IOWA DEPARTMENT OF NATURAL RESOURCES
ENGINEERING BUREAU
WALLACE STATE OFFICE BUILDING

ADDENDUM No. 1

GEODE STATE PARK
CAMPGROUND UPGRADE PROJECT
HENRY COUNTY, IOWA
PROJECT NUMBER: 18-06-44-01

November 14, 2017

SANITARY PLAN (SOUTH PORTION)

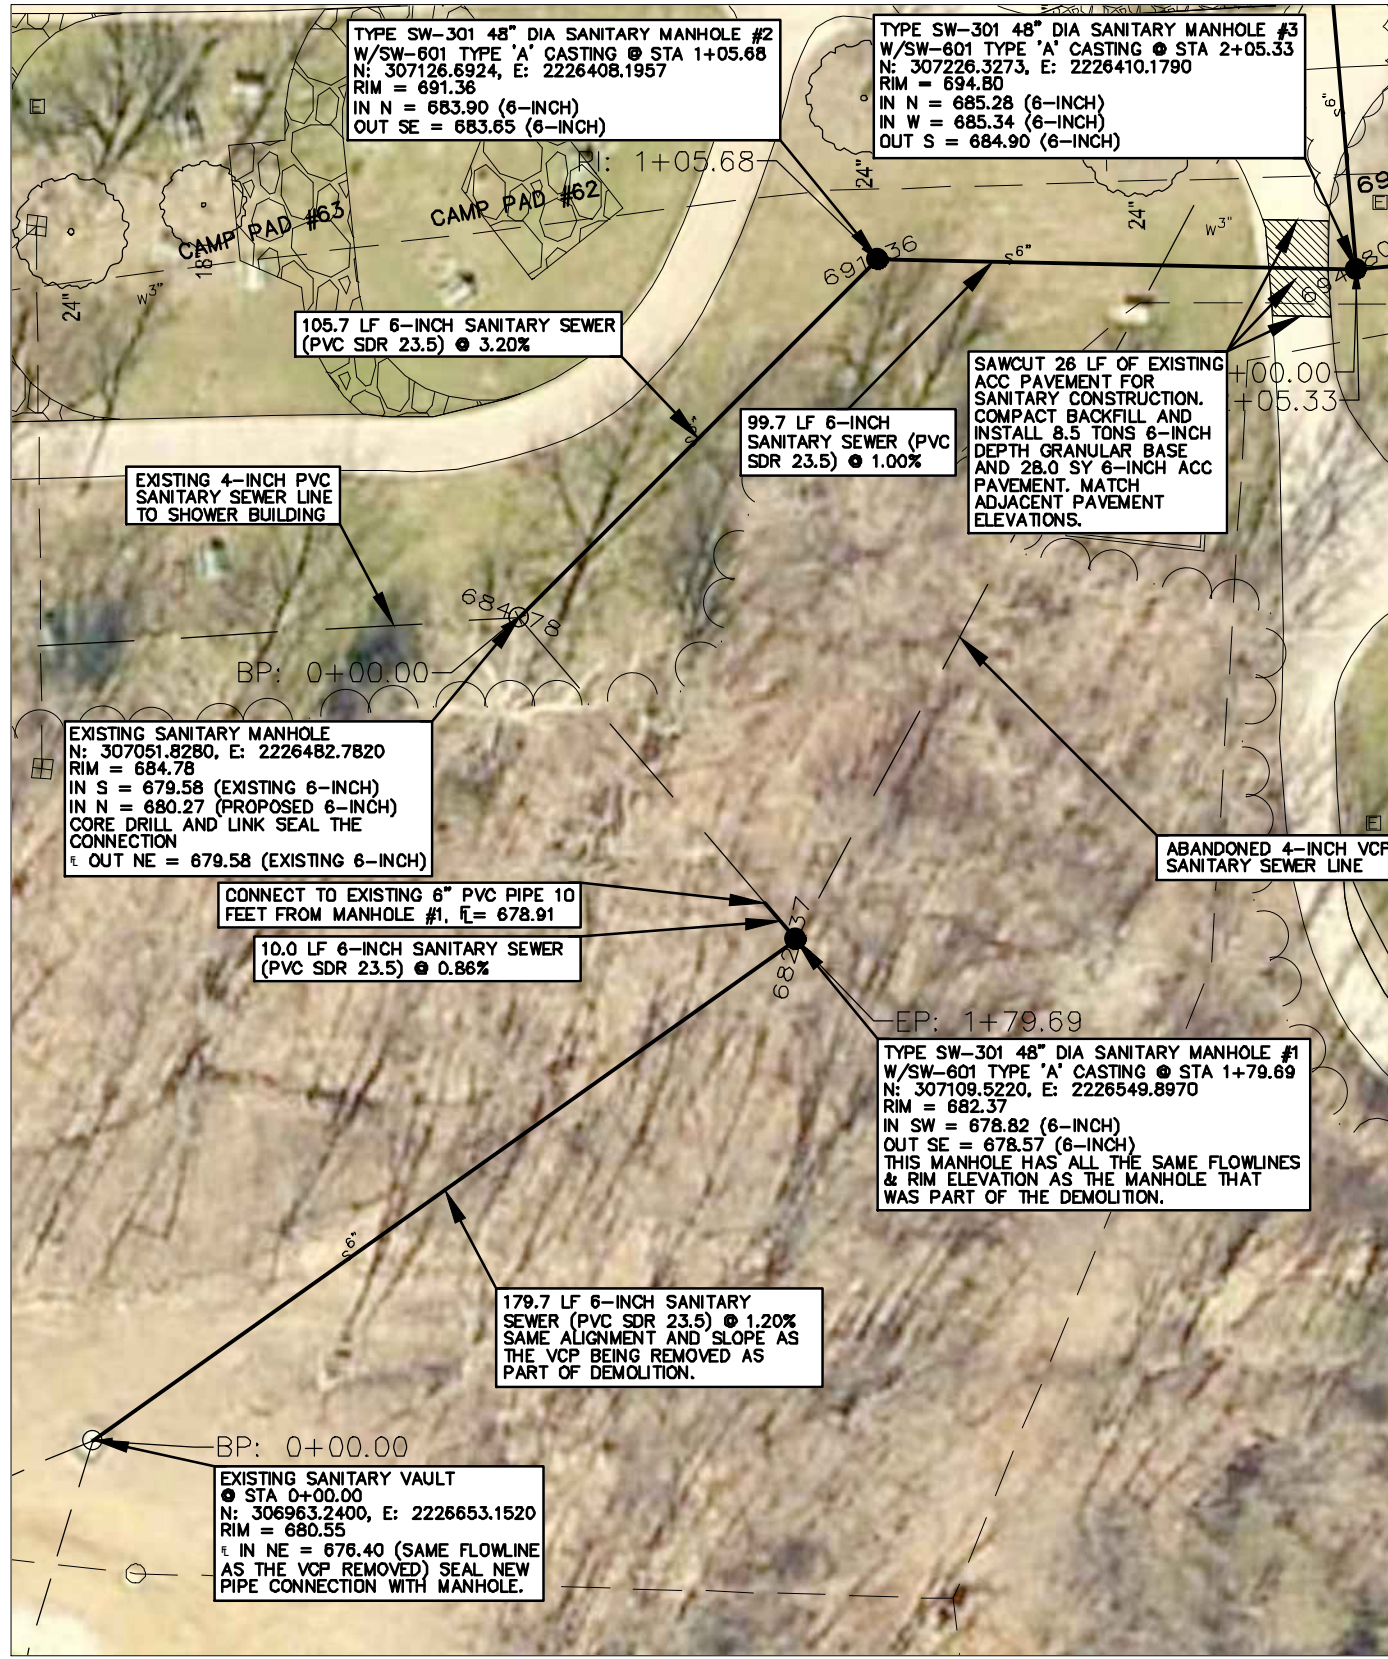
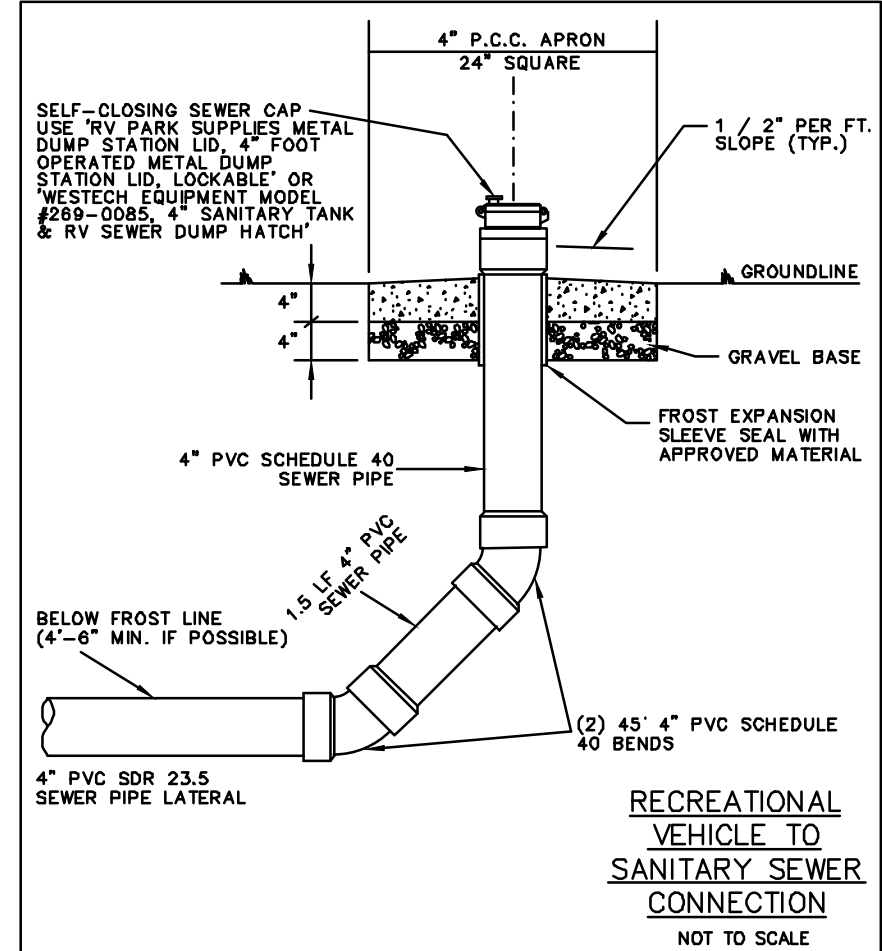
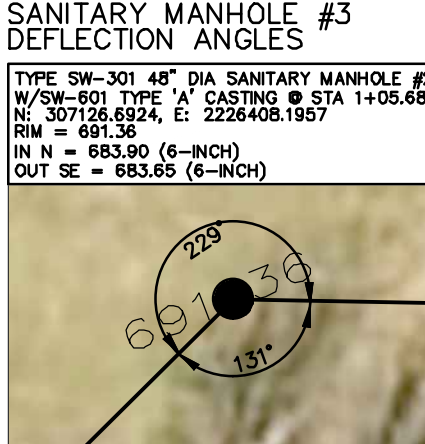
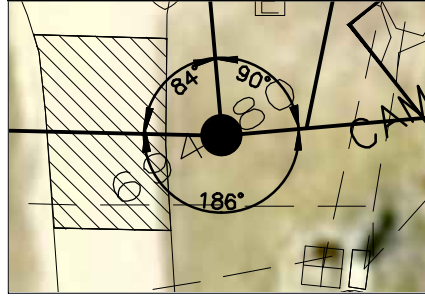
- A. Revised Sheet #3, QUANTITIES & GENERAL NOTES, Bid items #49, 50 and 51 have been updated. Item description for #11, RV SANITARY SEWER CLEANOUT CONNECTION has been revised to reference Sheet #10.
- B. Revised Sheet #10, SANITARY PLAN (SOUTH PORTION), the detail for the RECREATIONAL VEHICLE TO SANITARY SEWER CONNECTION note for the self-closing sewer cap has been revised and references (2) different suppliers for the clean-out.
- C. Revised Sheet #26, ELECTRICAL DETAILS, the sheet has been revised to include a detail for the 50-amp campsite outlet post.
- D. On Sheets #11 & 38, disregard the "6" PCC SLAB, 2" INSULATION & 4" GRANULAR BASE" for the PROPOSED SHOWER BUILDING note. The Huffcutt shower building is to be installed per manufacturer specifications.
